LTR2773

September 24, 1996

Reference: USNRC Letter of August 29, 1996

Subject: Request for Information Regarding 10 CFR Part 50, Appendix B
Controls on Supplied Equipment

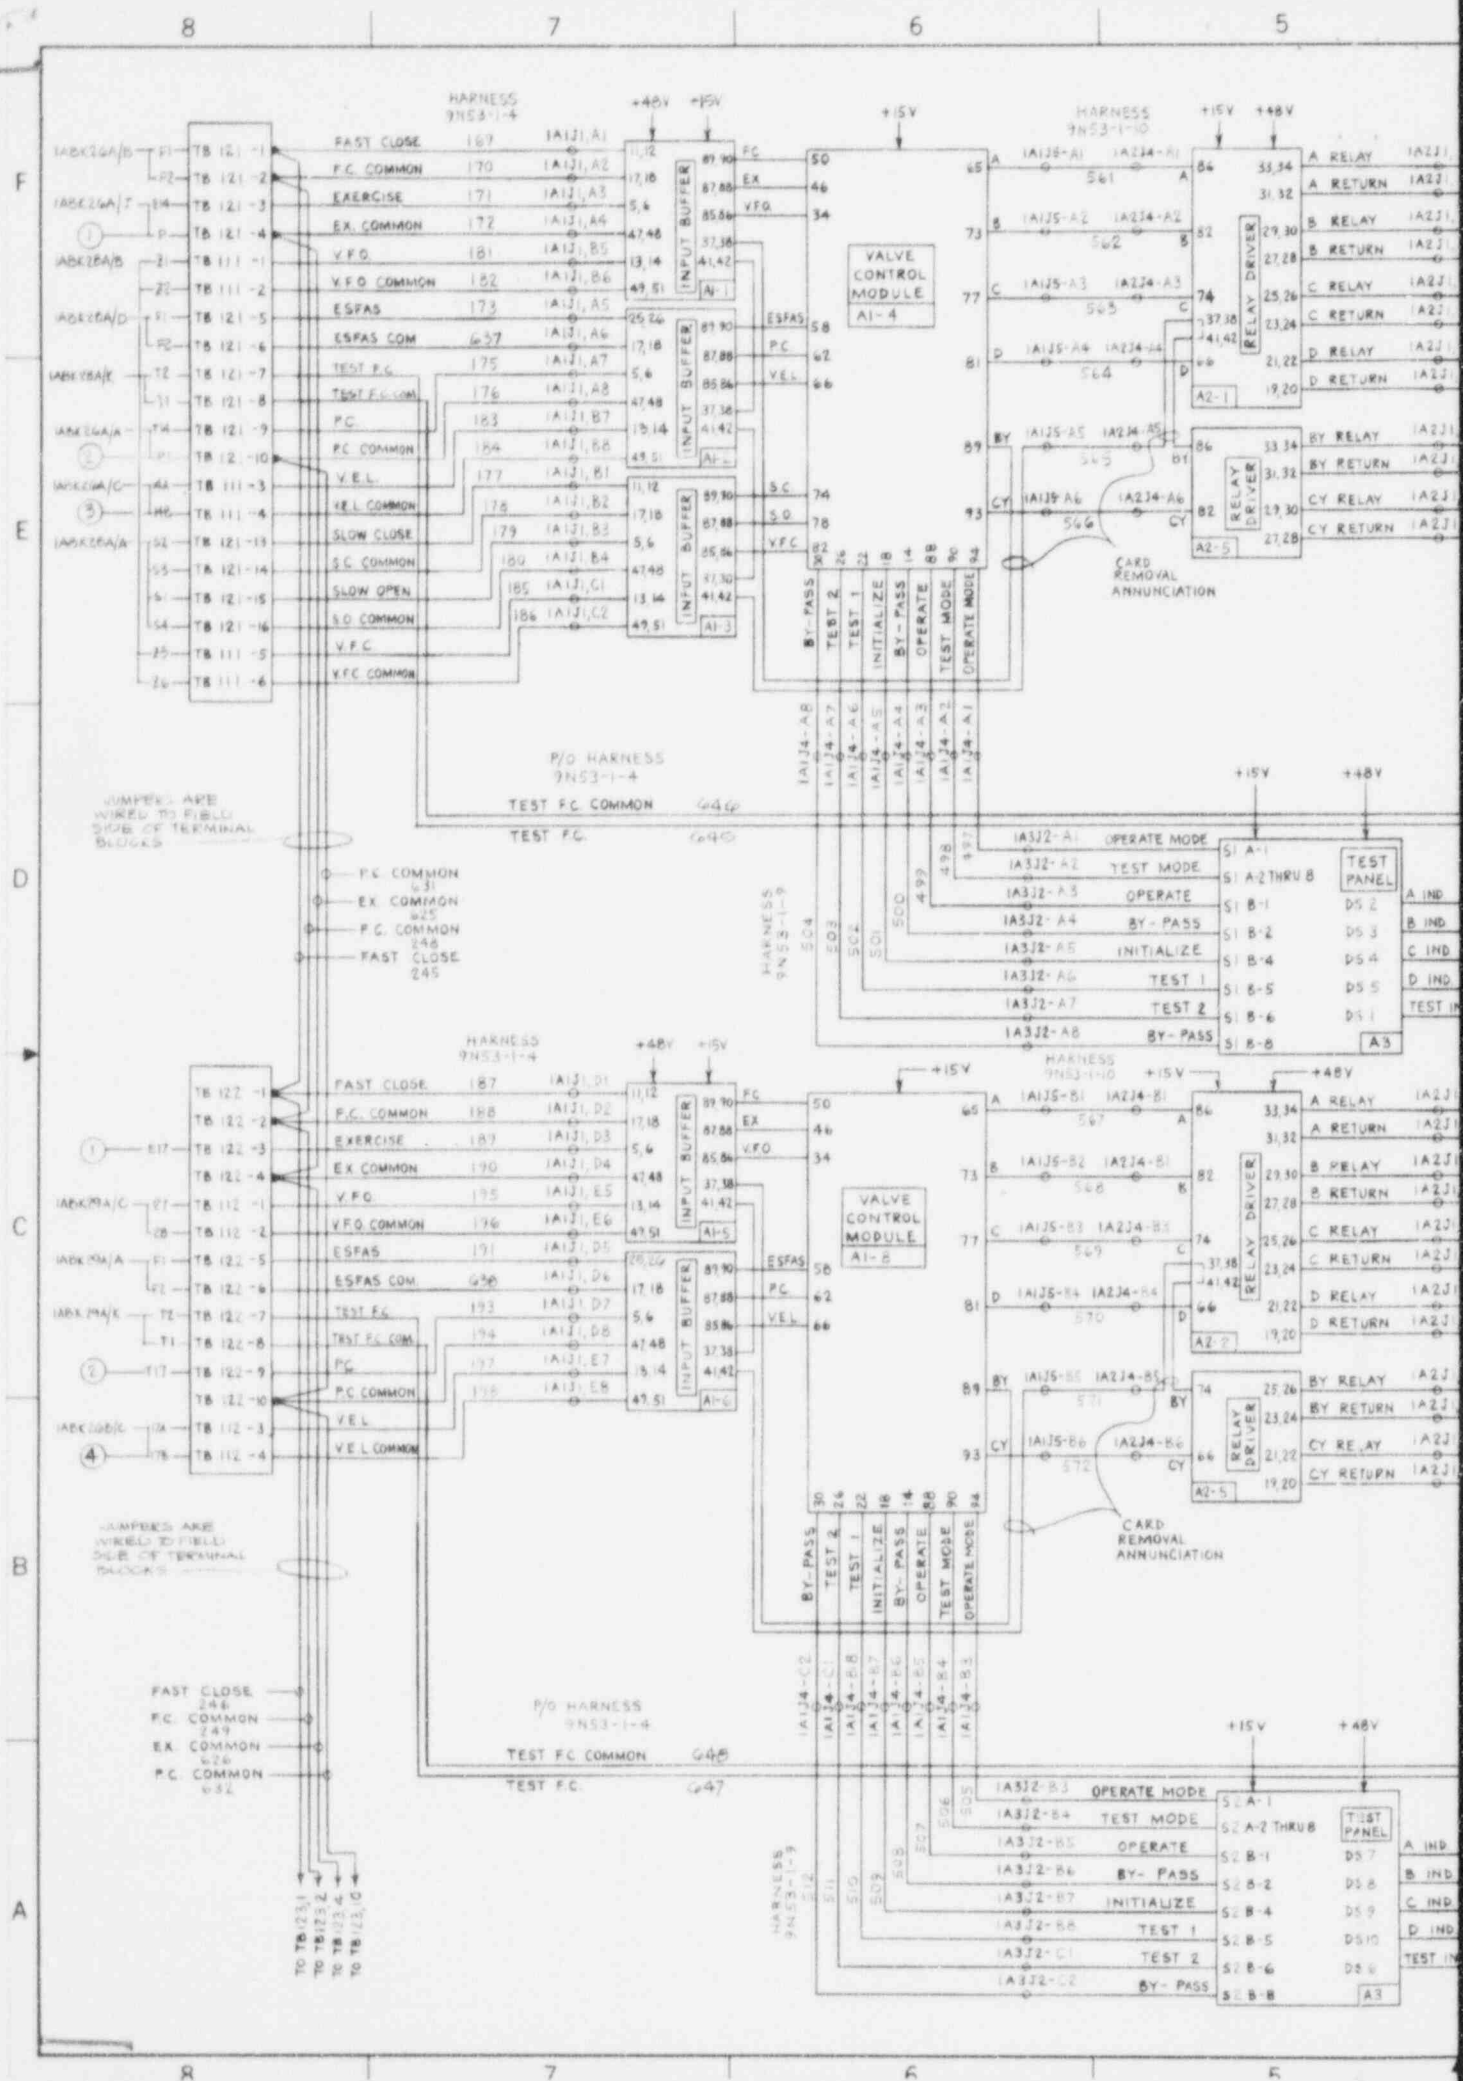
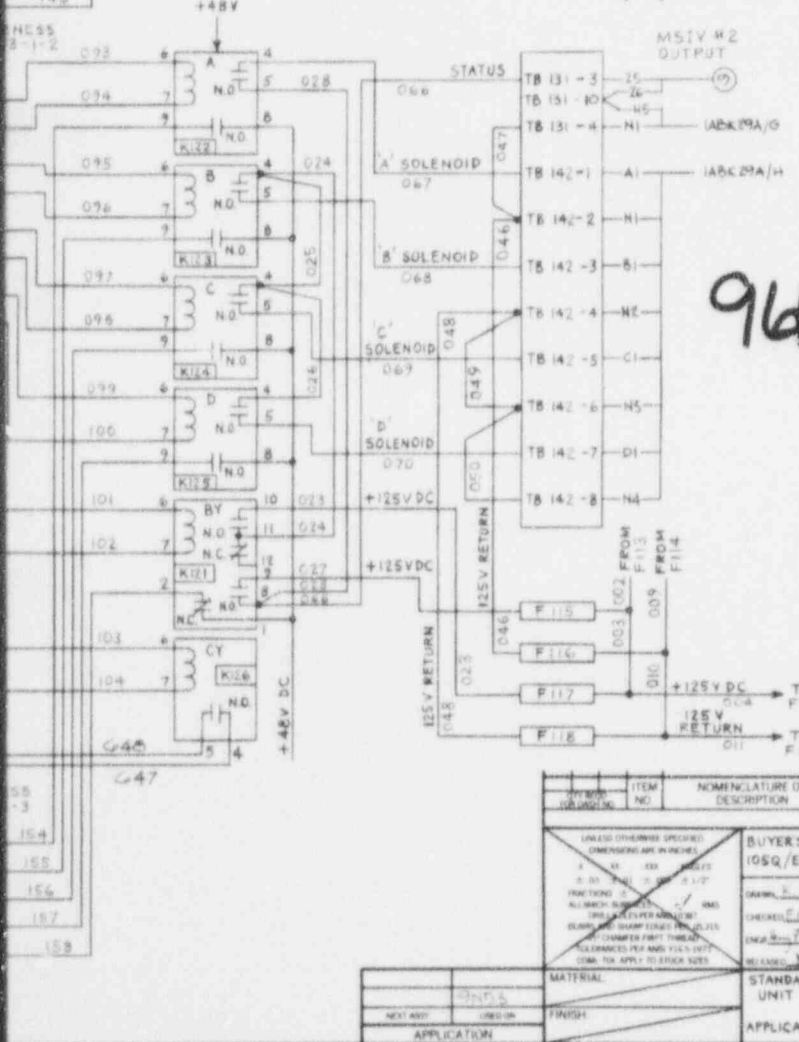
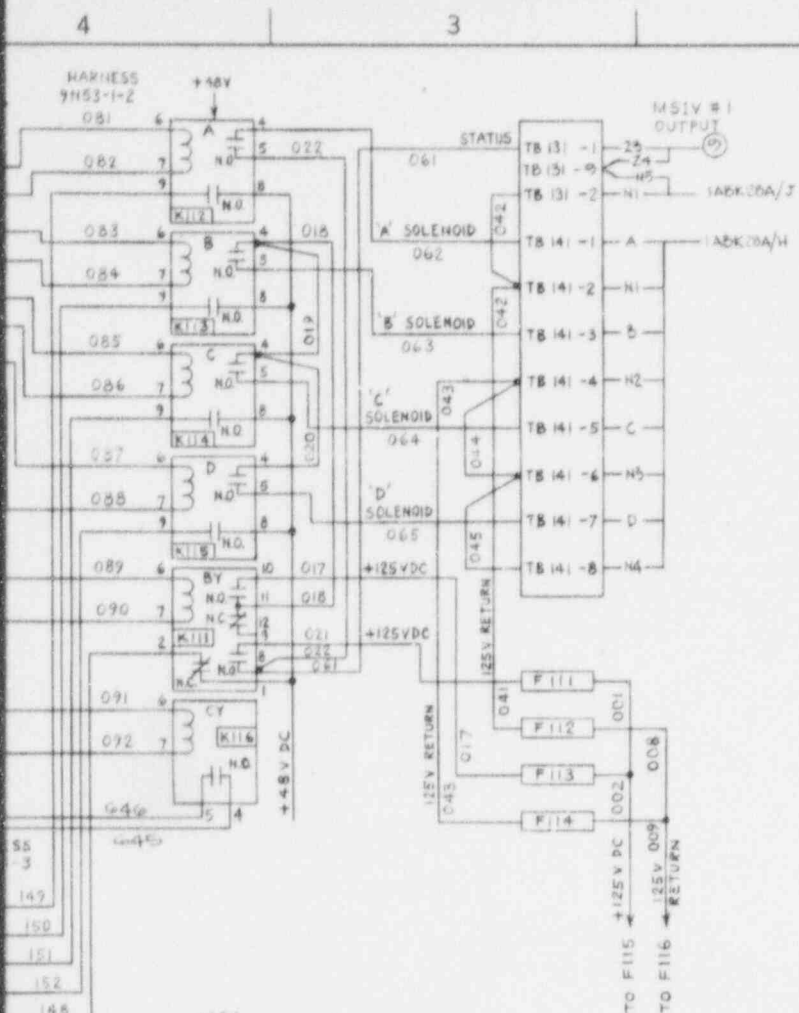
ATTACHMENT A is a copy of Bechtel specification 10466, figure 1 and a typical sheet from the Signal Flow Block Diagram KF8909. The highest voltage available on the relay circuit is 140VDC. The block diagram KF8909 is unique to the Main Steam and Feedwater Isolation System as supplied only to Callaway and Wolf Creek.
